RE: **Lot 4 Block 11 Unit 5 Volcano Cliffs SAD 227**
6301 Casa Blanca NW
Grading and Drainage Plan
Engineers Stamp Date 12/10/19 (E10D070)
Pad Certification Date: None provided
CO date: 12/16/2020

TITLE: 6301 CASA BLANCA NW
GRADING & DRAINAGE PLAN

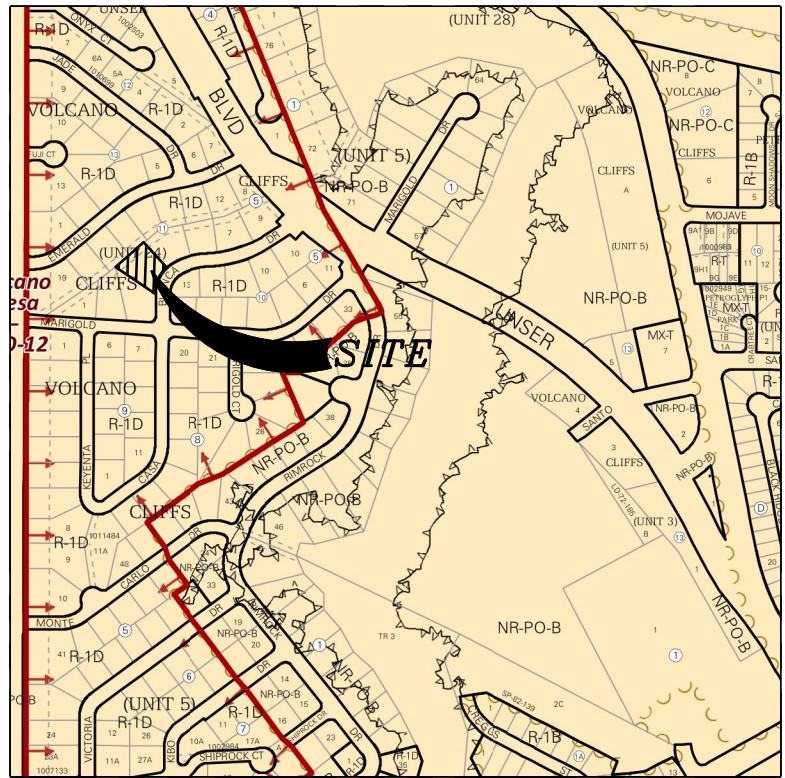
- Provide the size of pond in the rear yard.
- Adjust the land treatment values.
- Have the gravel swales in place.
- Have the drive pad in place.
- Provide the correct date in the CO language for the approved plan.
- Make sure all landscaping is in place which controls the drainage for this site.
